IN THE DRAWINGS:

Fig. 8

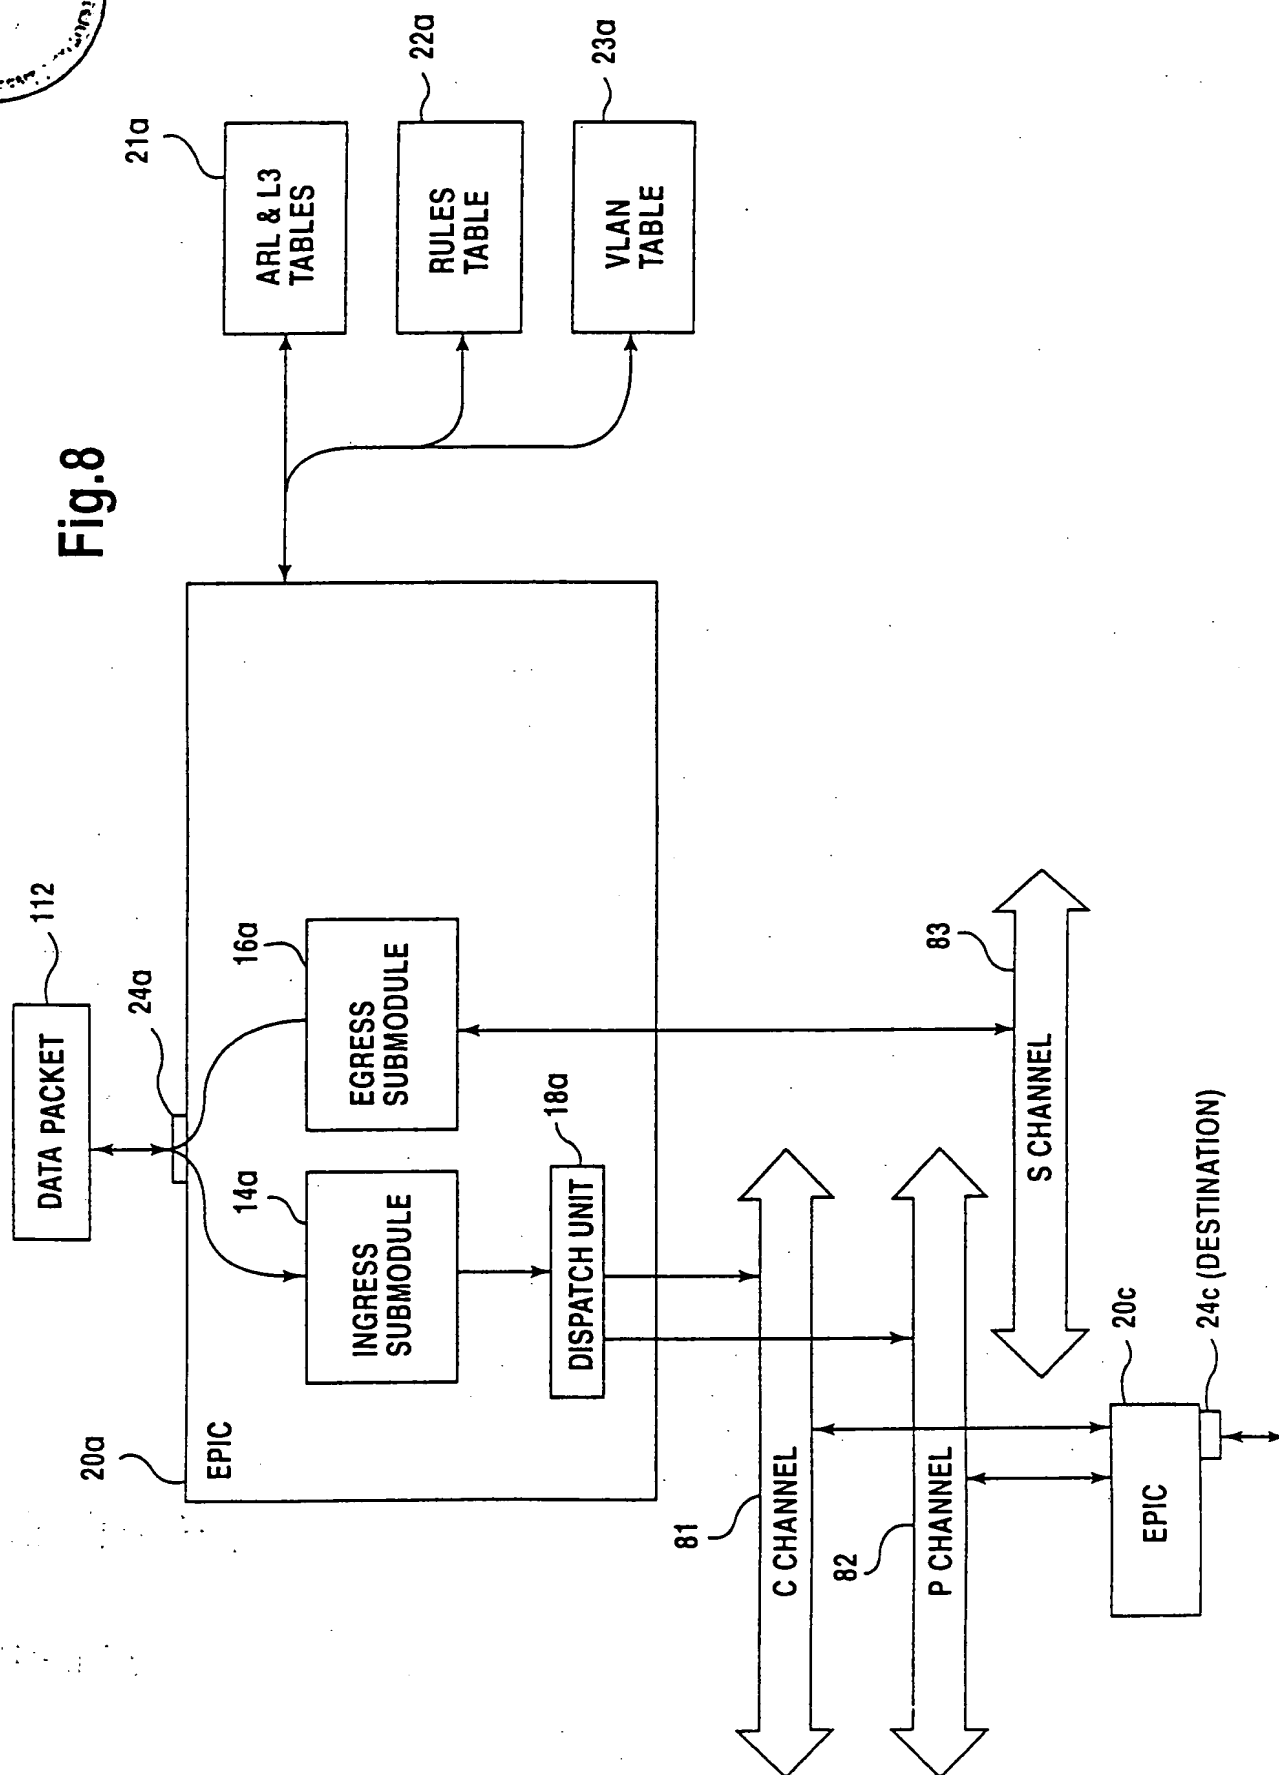
Please replace the original sheet containing Fig. 8 with the attached replacement sheet containing Fig. 8. The label for element 112 has been corrected to read "DATA PACKET" instead of "DATA POCKET".

Fig.25

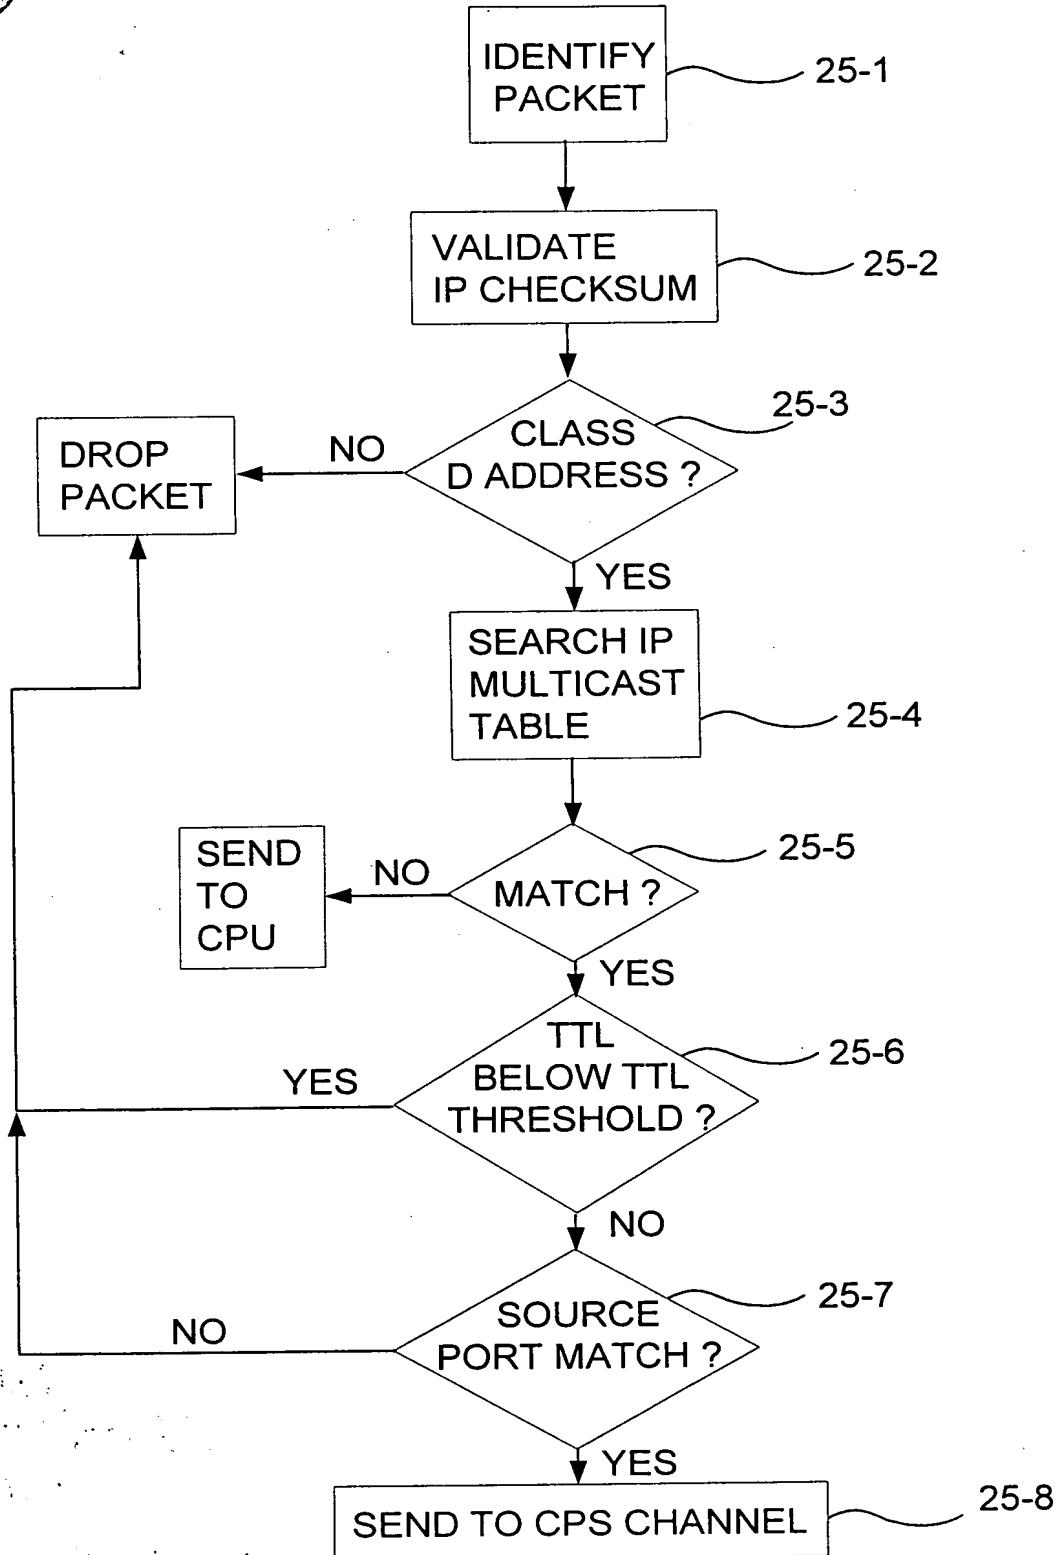
Please replace the original sheet containing Fig. 25 with the attached replacement sheet containing Fig. 25. Numerical references "25-6", "25-7" & "25-8" have been added to the lower elements in Fig. 25 to comply with their recitation in the specification.

Fig.28

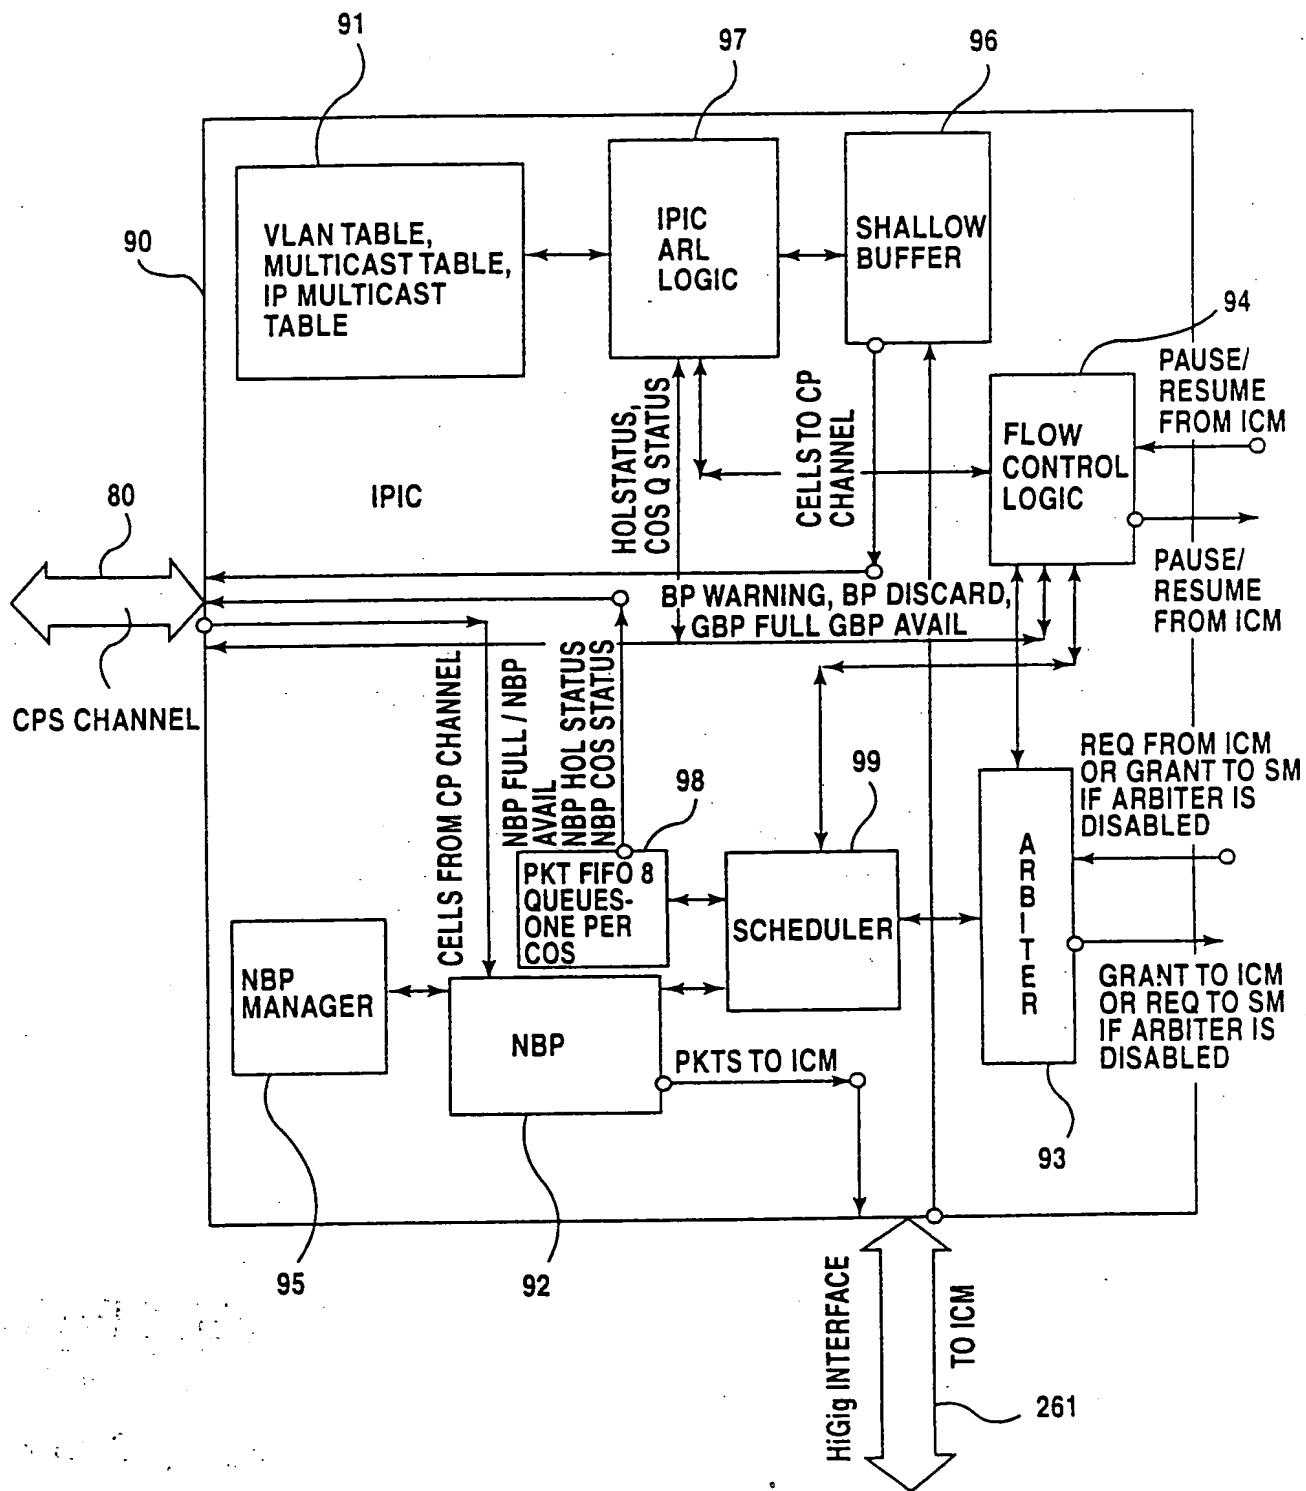
Please replace the original sheet containing Fig. 28 with the attached replacement sheet containing Fig. 28. The label for element 94 has been corrected to read "FLOW CONTROL LOGIC" instead of "FOW CONTROL LOGIC".

Fig.36

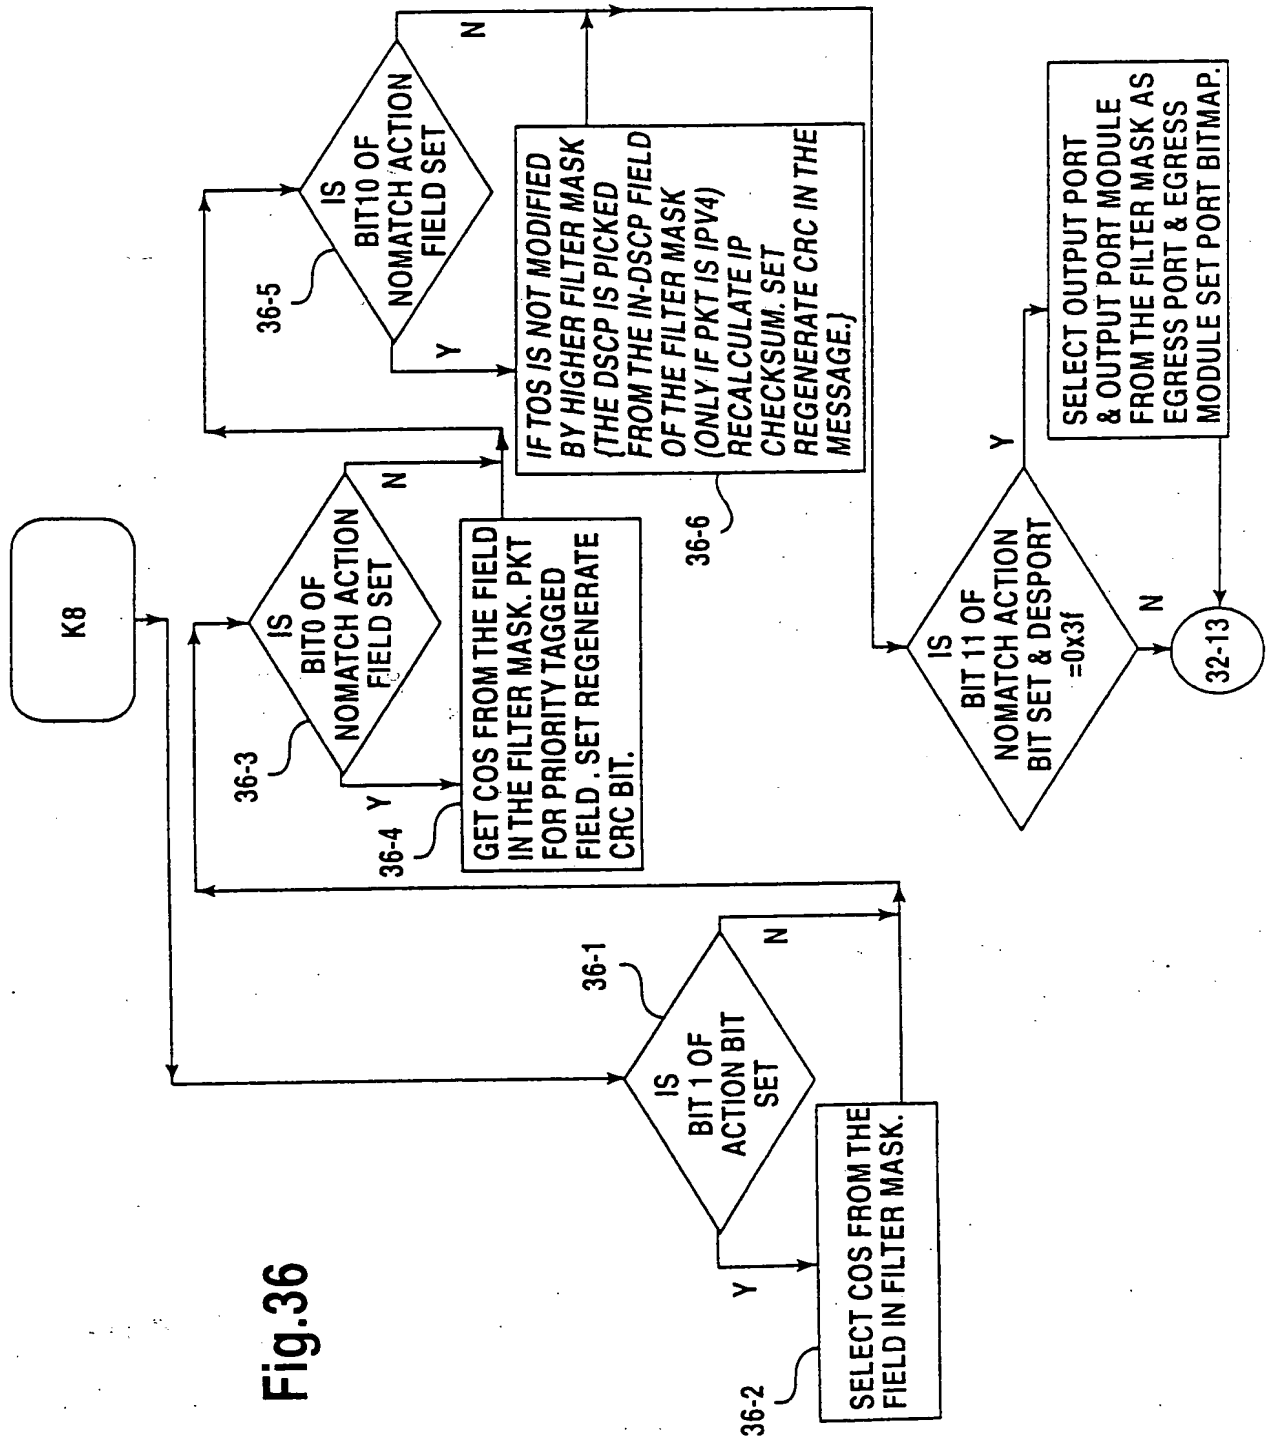
Please replace the original sheet containing Fig. 36 with the attached replacement sheet containing Fig. 36. The word "FILED", in elements 36-3 & 36-5, has been corrected to read "FIELD" in both elements.
